ADDENDUM NO. 1

BARNEY POND DAM – PEDESTRIAN BRIDGE RFP 2013-22 JUNE 3, 2013

NOTICE TO PROSPECTIVE BIDDERS

LEFT
 LOW LEVEL OUTLET
 GATE
 EXISTING CONDITIONS
 SHEET NO.: **9.0**

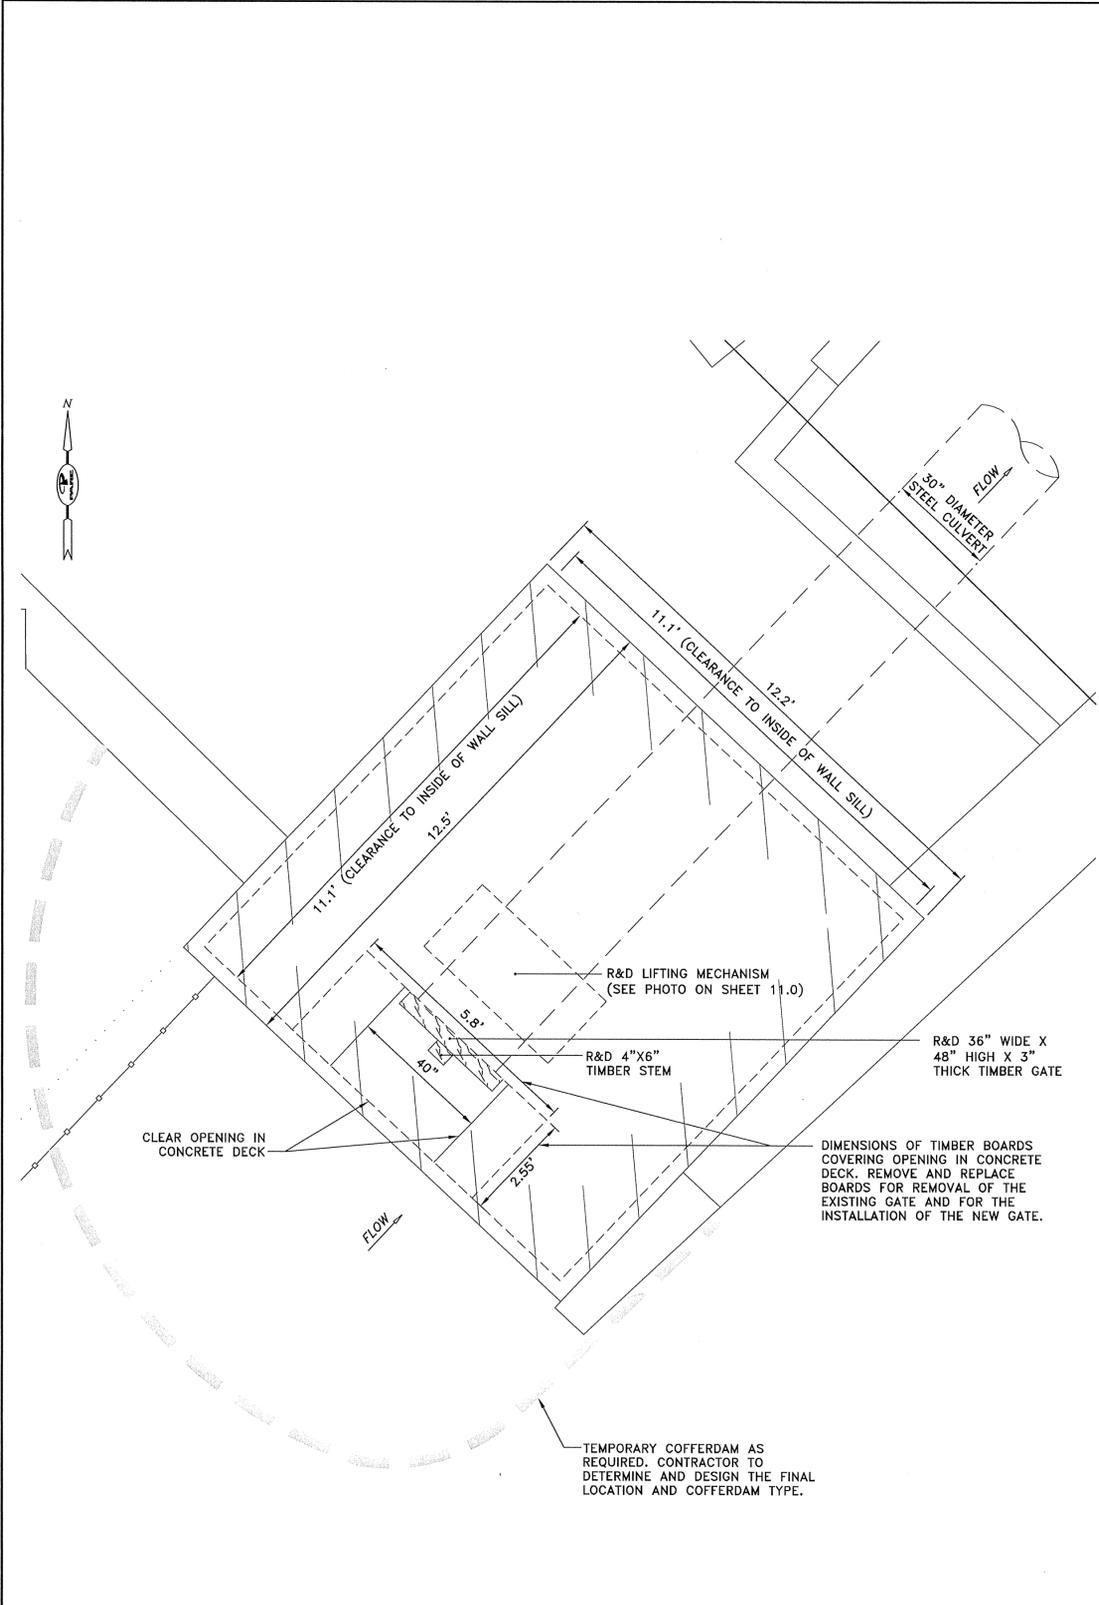
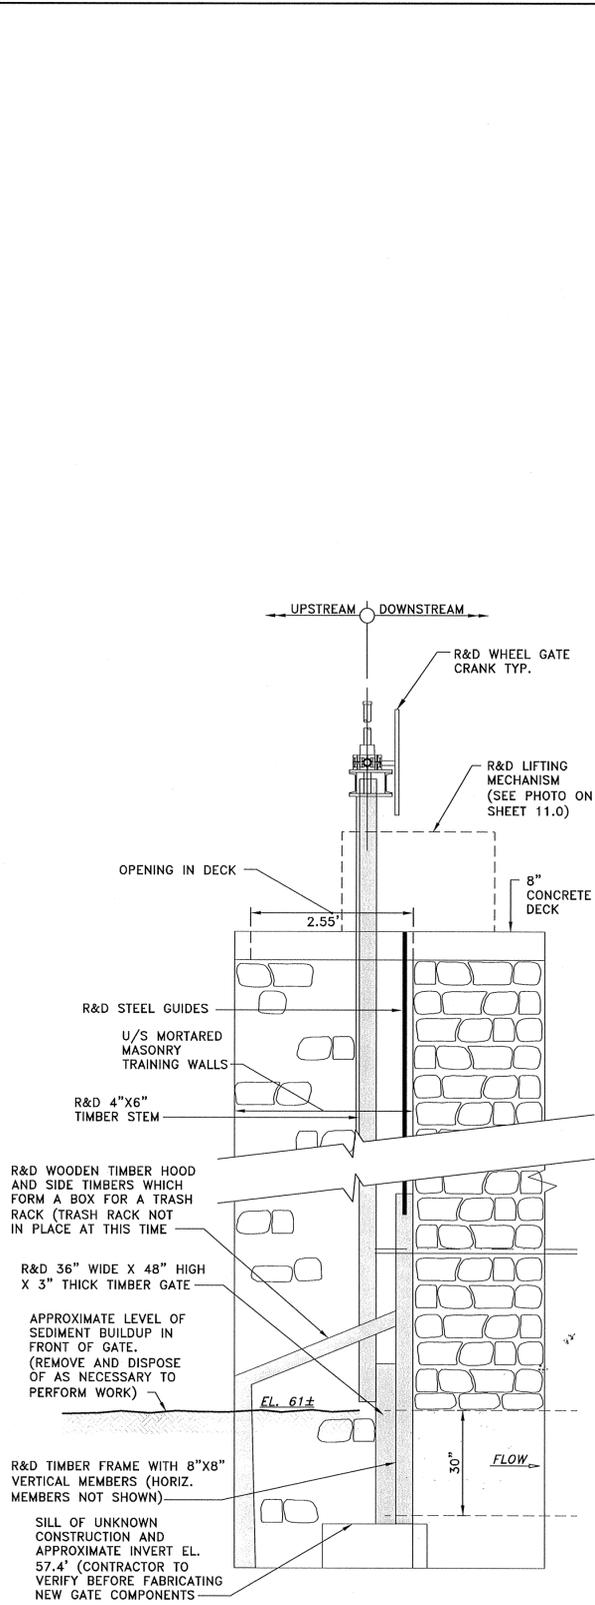
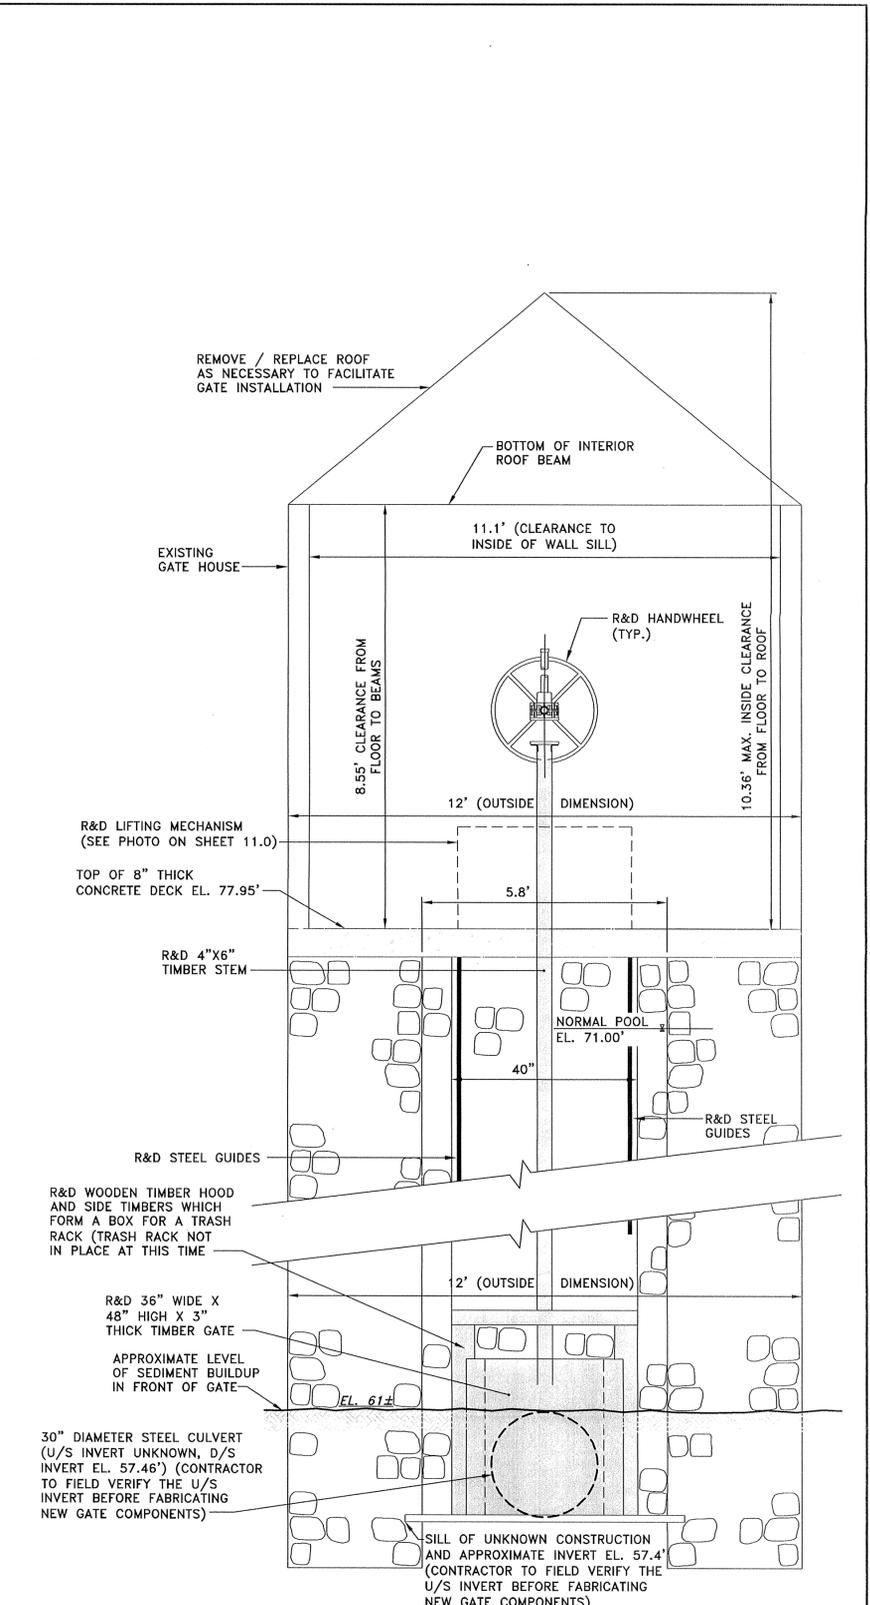
Please refer to the attached drawing. MAS has as built the gate and the attached sheet will show this. The scufal invert is at elevation 57.67' instead of 57.4' as shown on the plans. The sill will be set into place by using 6 to 10 inches of grout to lock it into place. Also, the existing finish floor elevation of the gate house is 77.89' instead of 77.50' as shown on the plans. Therefore, the approved gate that will be on site shortly is 4 inches taller than what the drawing shows. Please confirm that it is ok that the wheel for the gate sits 40" above finished floor, instead of the 30" shown on the plans.

Per Item 12.003 of Progress Meeting No. 13 minutes, the Town does not have an issue with the new gate wheel being set 4 inches higher than shown on the Contract Documents.
